**Subject: Processed Kimberlite Containment Facility Modification**

Diavik Diamond Mines (2012) Inc. (DDMI) is requesting approval for a modification to the North Dam of the Processed Kimberlite Containment Facility (PKC). This request is made under Water License W2015L2-0001 Part G Item 1.

**TASK NORTH COUNTRY ROCK PILE - ROCKFILL PLACEMENT ALONG THE NORTH DAM  
DESCRIPTION CREST**

TITLE  
**NORTH DAM CREST ROCKFILL PLACEMENT PLAN AND SECTION**

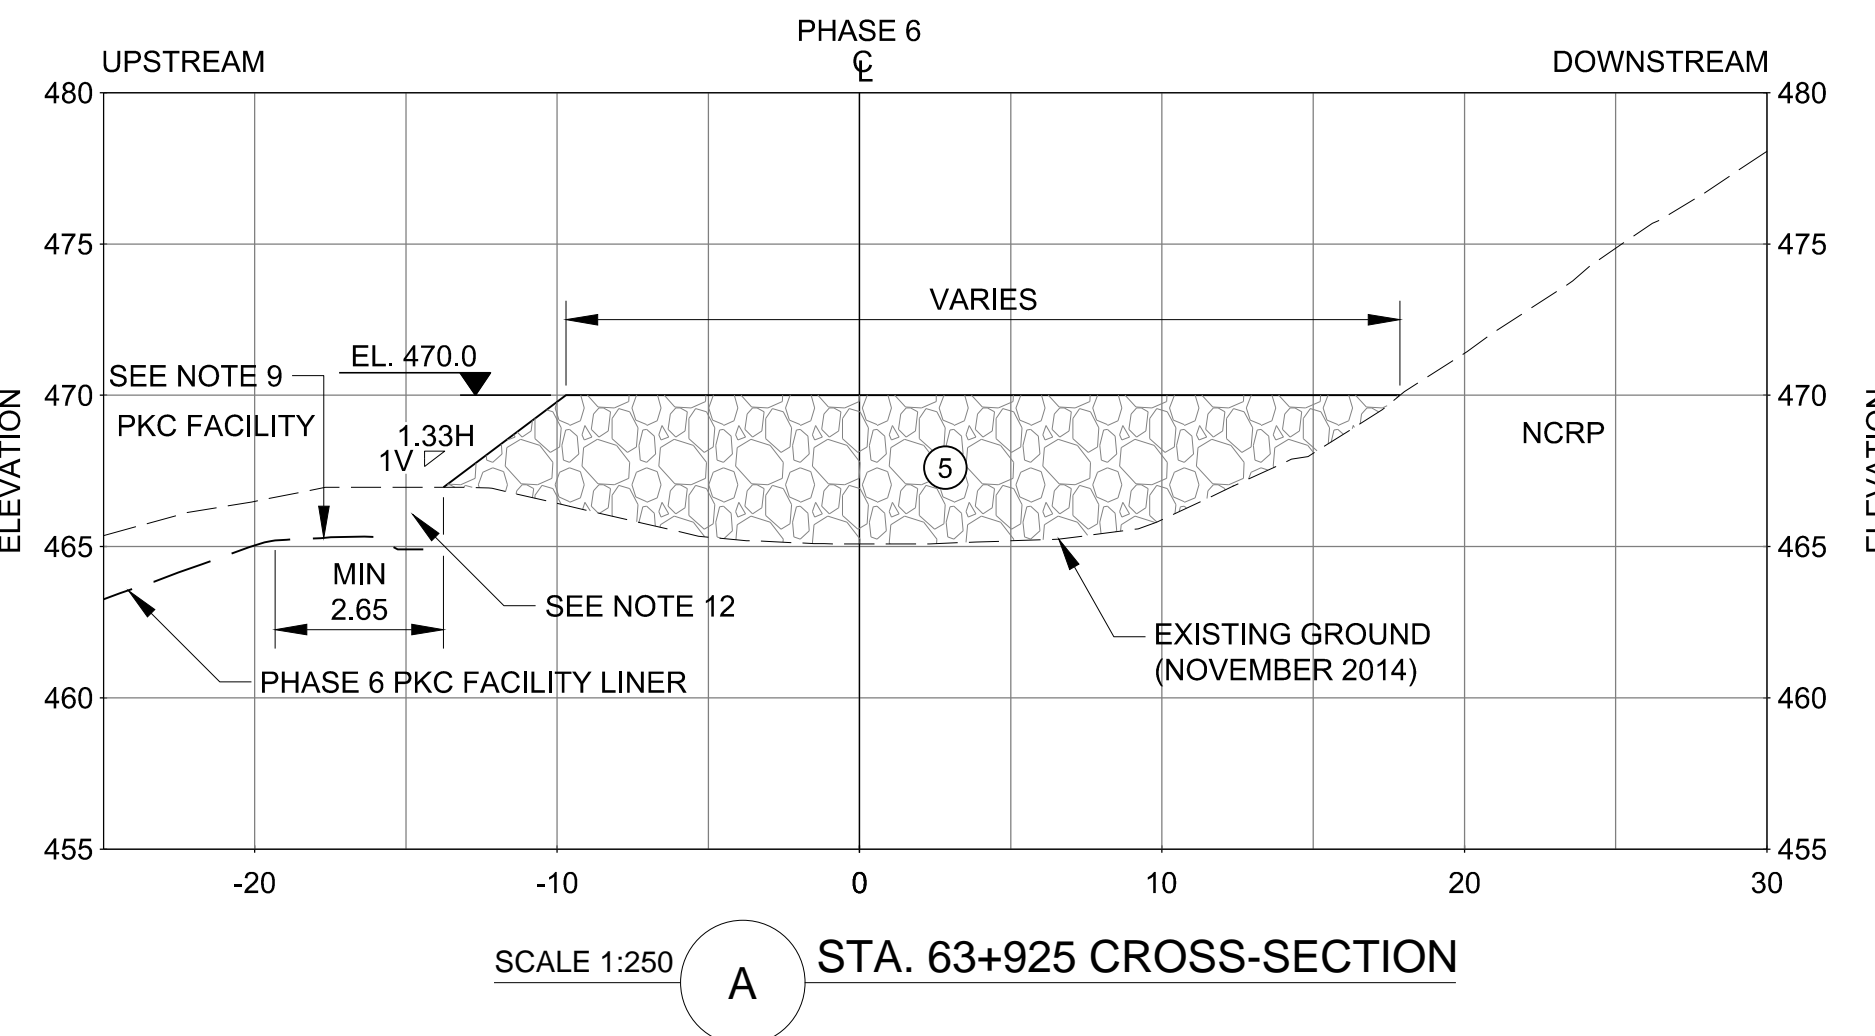
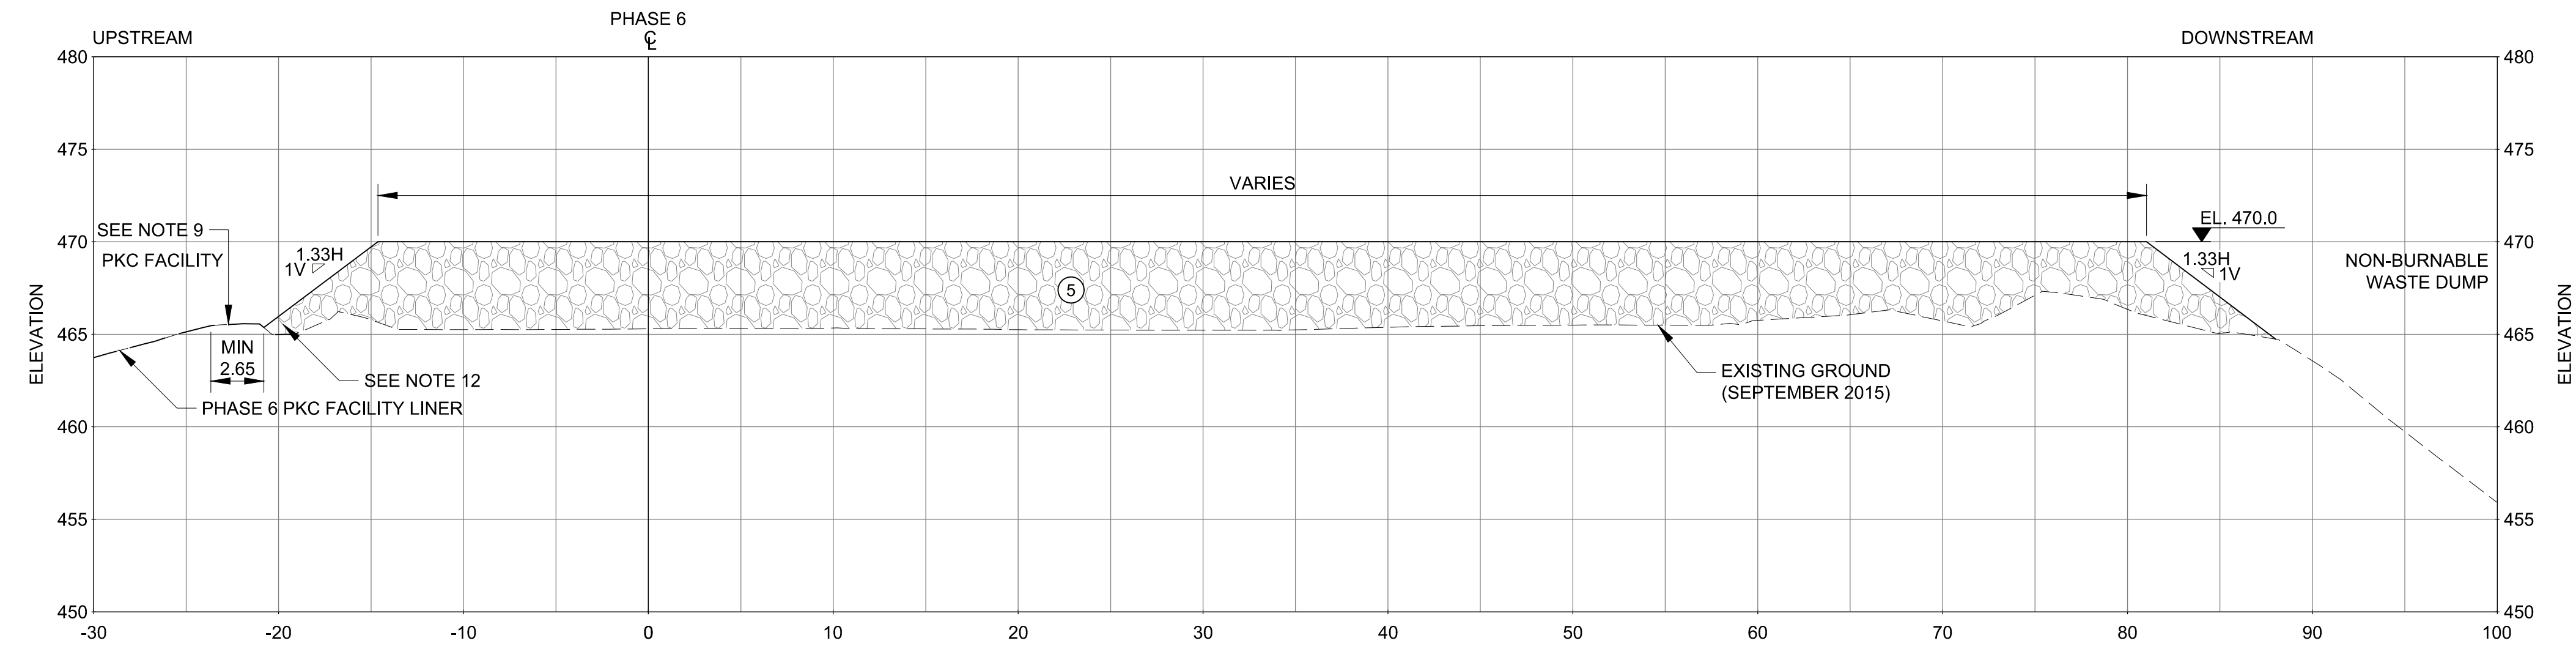
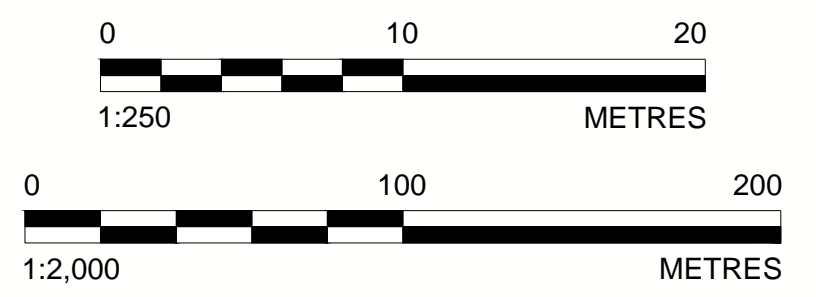
DDMI will be placing a 5 meter lift of Type III waste rock from the Underground Mine along the North Dam. This lift would be used, if required, for the Phase VII Dam Raise and would be constructed using the Phase VI Design Specifications. DDMI confirms that once this modification is approved, the Waste Rock Management Plan (Version 7) will be revised and submitted for approval by March 31, 2016.

Placement of Type III ROM rockfill along the North Dam crest is presented in plan and cross-section in Drawing 001 attached to this technical memorandum.

The rockfill layout comprises placement of a 5 m lift between approximate Sta. 63+650 and 64+700. A 2.65 m offset from the surveyed crest of the existing PKC Facility Phase 6 liner crest at elevation 465 m has been included in the design to allow for potential use of the upstream slope of the rockfill for future raises of the PKC Facility dam. The rockfill placement layout has been restricted to the limits of the North Dam Type III rockfill area and does not enlarge the area of the NCRP Type III ROM. The minimum rockfill crest width has been designed to allow one-way traffic of 785 haul trucks. A minimum width of 18.9 m east of approximate Sta. 64+250 (including a shoulder barrier on one side only) and 24.1 m west of approximate Sta. 64+250 (including shoulder barriers on both sides) is required for 785 haul truck one-way traffic. The minimum rockfill crest width east of Sta. 64+250 is about 26.3 m. The crest width west of Sta. 64+250 is more than 60 m wide.

The NCRP buttresses the downstream slope of the PKC Facility North Dam and placement of rockfill between Sta. 63+650 and 64+700 from elevation 465 to 470 m is not considered to negatively impact the stability of the North Dam. No stability analyses were completed as part of the North Dam rockfill placement design.

The Type III ROM rockfill to be placed along the North Dam within the NCRP may be used for potential future raises of the PKC Facility dams therefore it is recommended to follow the PKC Facility Phase 6 technical specifications for rockfill placement (Golder 2011). As such, the Type III ROM rockfill shall satisfy the specifications for Zone 5 material placement and compaction including:

- CPK and snow shall be removed within the footprint of the Type III ROM rockfill placement area, where greater than 200 mm and 100 mm, respectively.
- The maximum rockfill lift shall be 5 m when placed with 220 tonne haul trucks. The maximum lift shall be reduced to 2.5 m when placed using 100 tonne haul trucks.
- Effort should be made to sort the rockfill such that finer material is placed on the upstream side of the lift (PKC Facility side) and the coarser material is placed on the downstream side. The rockfill on the upstream side of the lift, within 35 m from the surveyed crest of the existing PKC Facility Phase 6 liner, shall have a maximum particle size of 900 mm.
- Routing of the loaded haul truck traffic on the rockfill shall be carried out such that compaction is obtained across the entire width of the fill.
